UNITED STATES PATENT AND TRADEMARK OFFICE

APPLICATION NO.	FILING DATE	FIRST NAMED INVENTOR	ATTORNEY DOCKET NO.	CONFIRMATION NO.
10/712,286	11/12/2003	Robert J. Mills	14649	9293

Office Action Summary

DETAILED ACTION

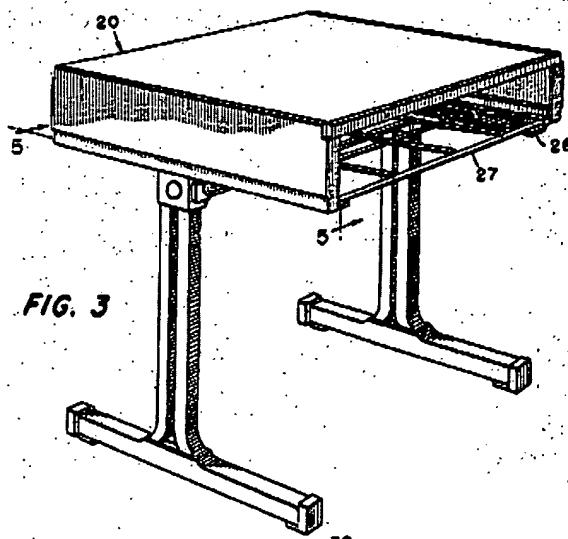
3. The drawings are objected to under 37 CFR 1.83(a). The drawings must show every feature of the invention specified in the claims. Therefore, the details of the first and second sections as shown in figures 1-3 must be labeled (following an updated description describing the elements as claimed) or the feature(s) should be canceled from the claim(s). No new matter should be entered.

Corrected drawing sheets in compliance with 37 CFR 1.121(d) are required in reply to the Office action to avoid abandonment of the application. Any amended replacement drawing sheet should include all of the figures appearing on the immediate prior version of the sheet, even if only one figure is being amended. The figure or figure number of an amended drawing should not be labeled as "amended." If a drawing figure is to be canceled, the appropriate figure must be removed from the replacement sheet, and where necessary, the remaining figures must be renumbered and appropriate changes made to the brief description of the several views of the drawings for consistency. Additional replacement sheets may be necessary to show the renumbering of the remaining figures. Each drawing sheet submitted after the filing date of an application must be labeled in the top margin as either "Replacement Sheet" or "New Sheet" pursuant to 37 CFR 1.121(d). If the changes are not accepted by the examiner,

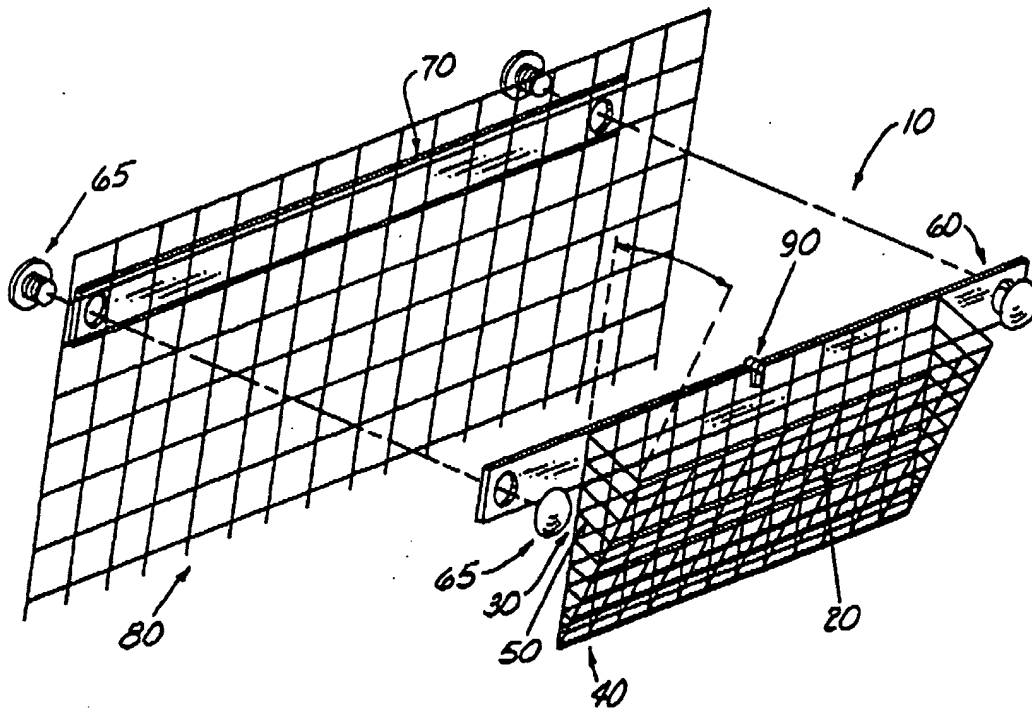
6. Lundahl teaches a pencil case (5) that has a portion (14) that is below the bottom of the typewriter (13) and the portion (14) is considered a bottom wall of the pencil case (5). The pencil case (5) has a first section (8) with a bottom wall (A'), opposing side walls (B', C'), a front wall (D'), and a rear wall (E'). The first section (8) is sized to retain a ruler or protractor within the walls. Rulers and protractors come in many sizes including some that are relatively small. Also note; a change in size is generally recognized as being within the level of ordinary skill in the art. *In re Rose*, 105 USPQ 237 (CCPA 1955). The pencil case is comprised of an upper compartment/ first section (8) and a lower compartment/second section (7). The lower compartment (7) is disposed next to or outside the typewriter (13). The second section (7) has a bottom wall and walls in the shape of circle and the circular wall is considered to be made of a front wall, a rear wall, and opposing side walls integral formed together. A third section (9) is higher than the first section and has a bottom wall, front wall, and a rear wall.
